UNITED STATES PATENT AND TRADEMARK OFFICE

APPLICATION NO.	FILING DATE	FIRST NAMED INVENTOR	ATTORNEY DOCKET NO.	CONFIRMATION NO.
10/604,555	07/30/2003	Jean Audet	CA920030012US1	1554
32074	7590	02/15/2005	EXAMINER	
INTERNATIONAL BUSINESS MACHINES CORPORATION DEPT. 18G BLDG. 300-482 2070 ROUTE 52 HOPEWELL JUNCTION, NY 12533			HYEON, HAE M	
			ART UNIT	PAPER NUMBER
			2839

Office Action Summary

DETAILED ACTION

FIG. 4

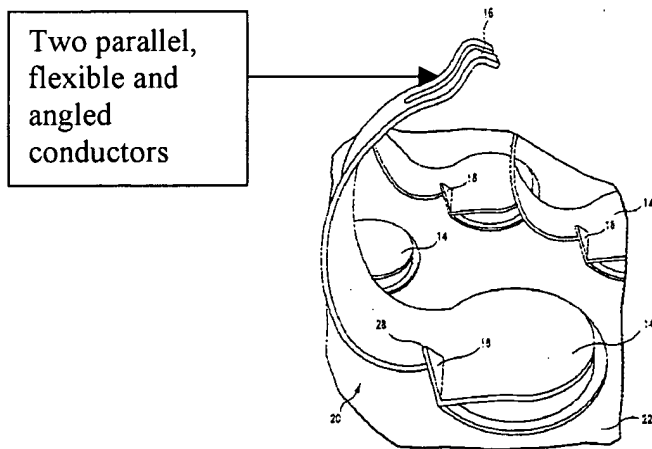
Guerin discloses an assembly of an integrated circuit (IC) package comprising a plurality of input/output (I/O) pads 34 on a surface of the IC package 32, a plurality of contact pads 26 on a substrate 22, and a plurality of electrically conductive connectors 12. Each of the connectors 12 comprises a first contact surface 16, a second contact surface 14 with a tab 18, and a flexible portion interconnecting the first and second contact surfaces 16 and 14. The first contact surface 16 of the connectors 12 is joined to an I/O pad 34 of the IC package 32 and the second contact surface 14 of the connectors 12 is joined to a contact pad 26 on the substrate 22 by solder. Each of the flexible portions is comprised of at least two parallel, angled and flexible conductors, wherein the conductors are electrically insulated from each other for a portion of their lengths.
